Environmental  
Protection Agency

June 20, 2011

RE: TRUMBULL COUNTY  
MESOPOTAMIA  
ADVANCE ECO-AGRICULTURE LLC  
NPDES PERMIT NO. OHC000003  
OHIO EPA PERMIT NO. 3GC05200\*AG  
CONSTRUCTION STORM WATER

Figure 4 – No inlet protection is present.

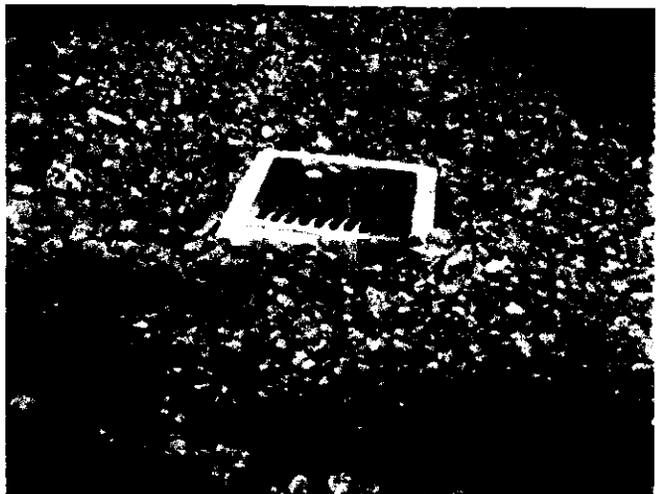
4. No inlet protection is present on the storm drain next to the manufacturing building (Figure 4), and sediment-laden water is visible in the catch basin (Figure 5). As stated in the NPDES permit, control practices must be utilized to minimize the amount of sediment that enters storm drains.
